Access Compliance Report

Public Rights-of-Way

Intersection ID: 10027733	Main Street: GRIFFITH_ST	Cross Street: N/A	Location: N
ADA ID: EEB46C205A38	Ramp Type: PerpDiag	Initial Pass/Fail: Fail	Overall Compliance: No
Severity Score: 22.5			
Codes/Mitigation Info/Possible Solution		Field Measurements/Component Compliance

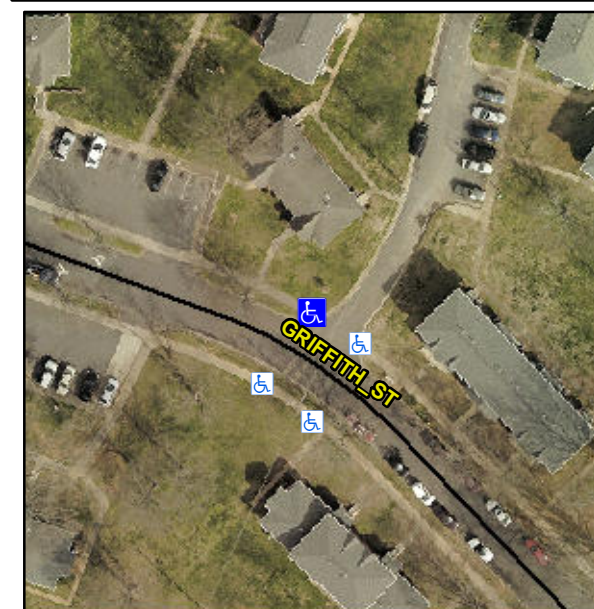
Not Found, R304.5.1, R304.2.2, R304.5.3

Compliance	Description	Data	Compliance	Description	Data
N/A	Ramp Length (in)	80.0	No	Ramp Slope (%)	8.7
No	Ramp Width (in)	45.0	No	Ramp XSlope (%)	3.1
N/A	Flare Type LT	N/A	N/A	Flare Type RT	N/A
N/A	Flare Slope LT (%)	N/A	N/A	Flare Slope RT (%)	N/A
N/A	Flare Traversable LT?	N/A	N/A	Flare Traversable RT?	N/A
N/A	Landing Length (in)	N/A	N/A	DWS Provided?	N/A
N/A	Landing Width (in)	N/A	N/A	DWS Contrast?	N/A
N/A	Landing Slope (%)	N/A	N/A	DWS Length (in)	N/A
N/A	Landing X Slope (%)	N/A	N/A	DWS Full Width?	N/A
N/A	Landing Curb? (Y/N)	N/A	N/A	DWS Offset (in)	N/A
N/A	Shared Landing?	N/A			
N/A	Gutter Ponding?	N/A	N/A	Gutter Slope (%)	N/A
N/A	Gutter Lip Ht (in)	N/A	N/A	Gutter X Slope (%)	N/A
N/A	Painted X Walk1?	No	N/A	Painted X Walk2?	No
	X Walk 1 Direction	To SW		X Walk 2 Direction	To SE
N/A	X Walk 1 Width (in)	N/A	N/A	X Walk 2 Width (in)	N/A
	X Walk 1 Slope (%)	1.5		X Walk 2 Slope (%)	2.5
	X Walk 1 X Slope (%)	2.1		X Walk 2 X Slope (%)	1.0

Remove & Replace Curb Ramp With Two New Directional Ramps or Equivalent.
